NOTICE TO MARINERS No 42 of 2021

Chart Correction - Coastline (Ferry Landing) in Id-Daħla tad-Dockyard at Il-Port Il-Kbir

Reference is made to BA Chart 177 – Valletta Harbours.

Chart affected: BA 177

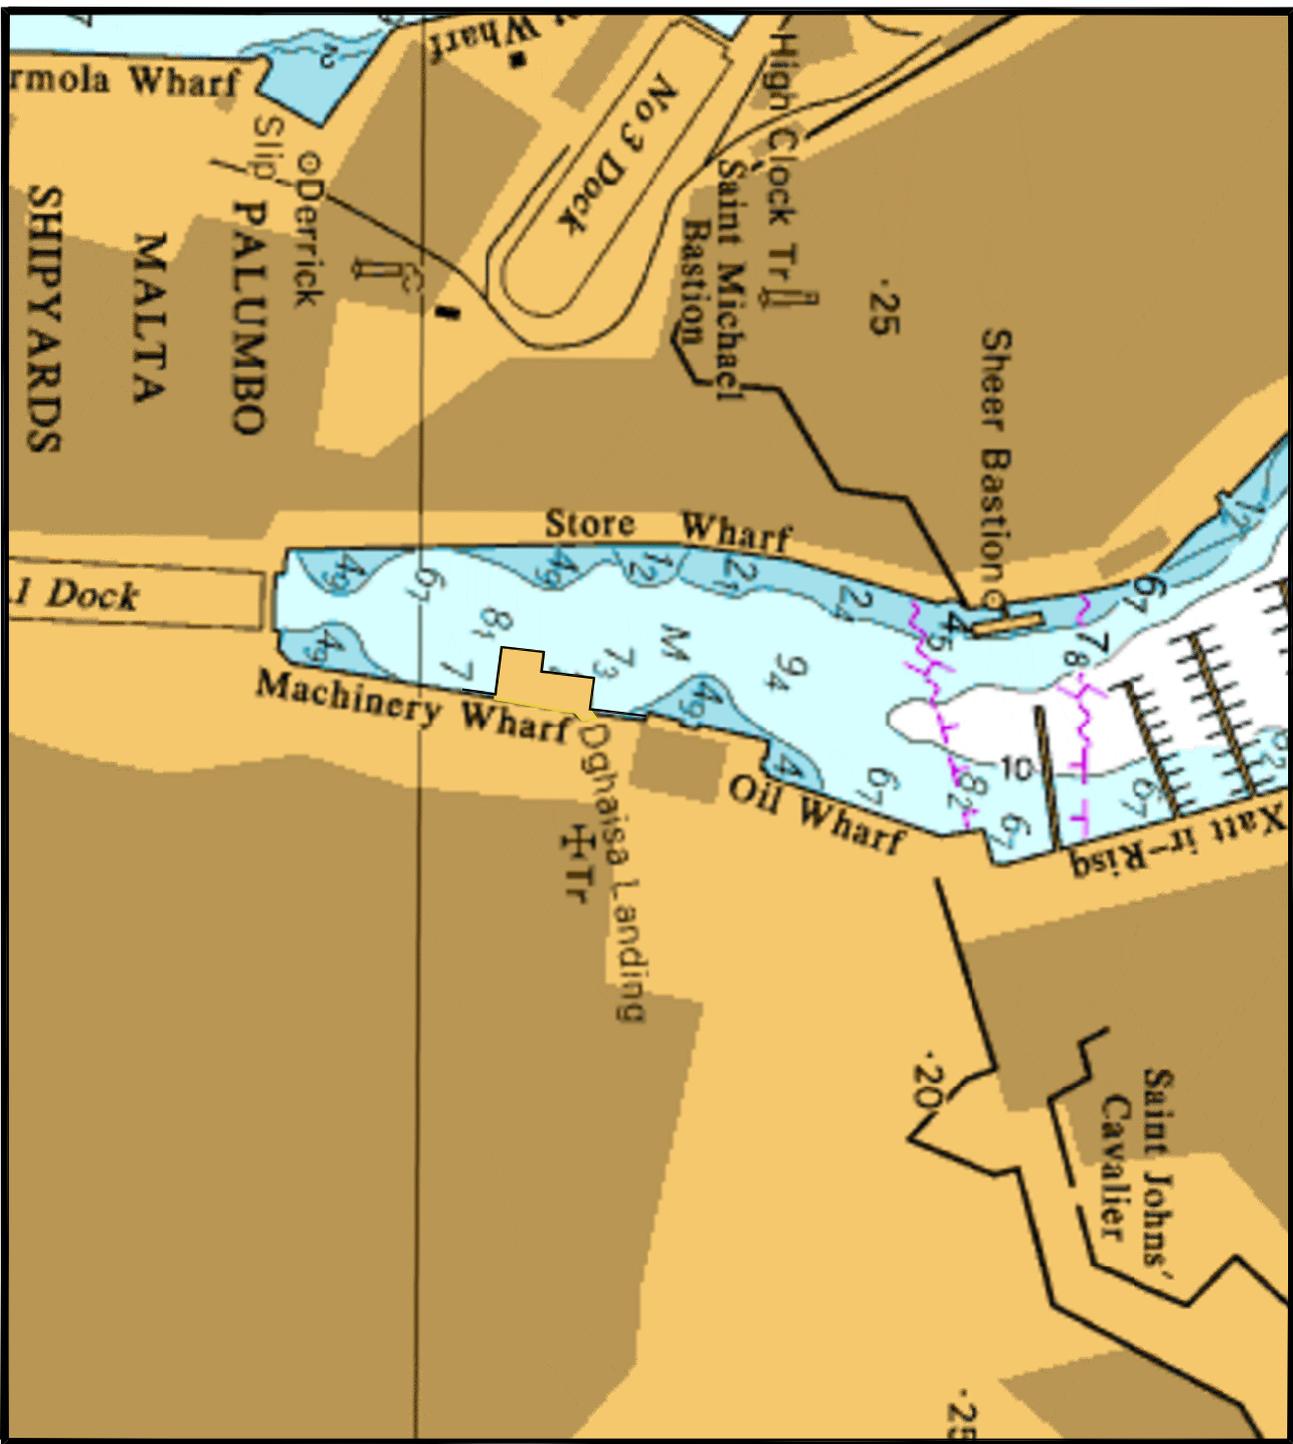
The Ports and Yachting Directorate, Transport Malta notifies Mariners that the following changes have been made to the coastline in in Id-Daħla tad-Dockyard at Il-Port Il-Kbir.

Latitude (N)	Longitude (E)
Insert	new coastline, joining:	(a)	35° 53'.017	014° 31'.233
			35° 53'.018	014° 31'.220
			35° 53'.027	014° 31'.221
			35° 53'.027	014° 31'.227
			35° 53'.039	014° 31'.228
		(b)	35° 53'.038	014° 31'.237
Delete	old coastline, joining		(a) to (b) above
